# Access Compliance Report

## Public Rights-of-Way

### (Curb Ramps)

| Intersection ID: 50476 | Main Street: BOW_RD | Cross Street: KINGS_RIDGE_DR | Location: S            |

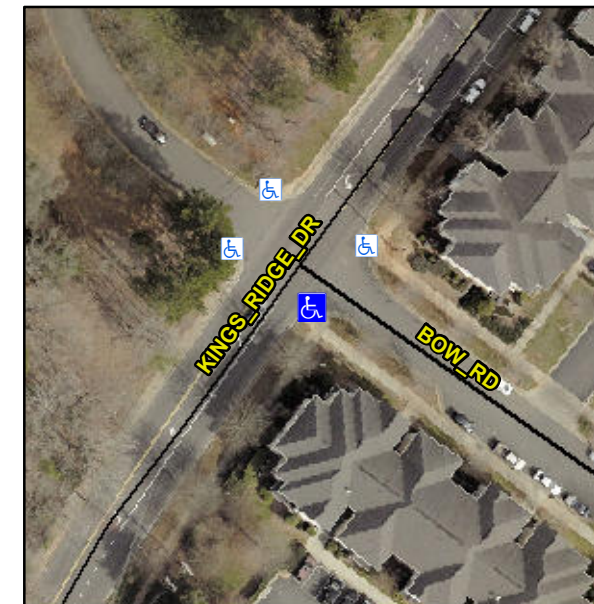
| ADA ID: F3094926FF7A   | Ramp Type: PerpDiag | Initial Pass/Fail: Fail      | Overall Compliance: No |

**Not Found, R304.5.1, R304.2.2, R304.5.3**

| Compliance | Description           | Data  | Compliance | Description                 | Data  |
|------------|-----------------------|-------|------------|-----------------------------|-------|
| N/A        | Ramp Length (in)      | 77.5  | No         | Ramp Slope (%)              | 8.7   |
| No         | Ramp Width (in)       | 47.0  | No         | Ramp XSlope (%)             | 2.6   |

**Remove & Replace Curb Ramp With Two New Directional Ramps or Equivalent.**
